Duke Power Company
Oconee Nuclear Station

Attachment 1

Proposed Technical Specification Revision

No Significant Hazards Consideration Evaluation

OCONEE NUCLEAR STATION
MANAGEMENT ORGANIZATION CHART
Figure 6.1-2

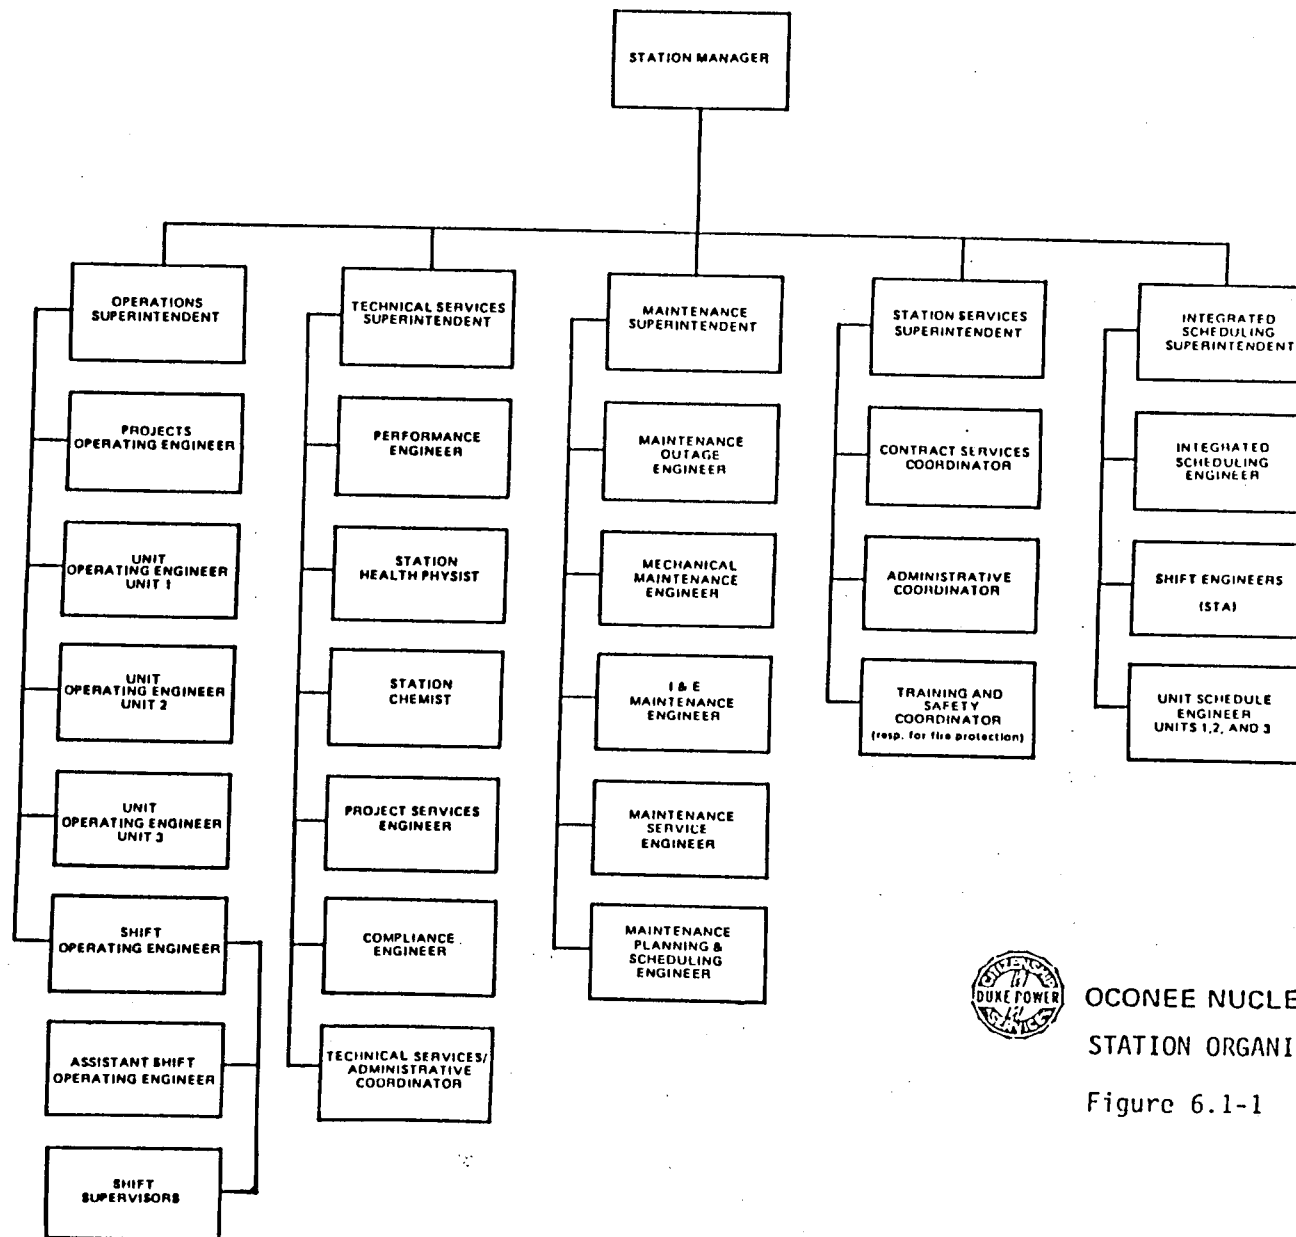
The final revisions are updates to the Station Organizational Chart and Management Organization Chart, for Oconee Nuclear Station, to achieve consistency with Duke Power's current organization.
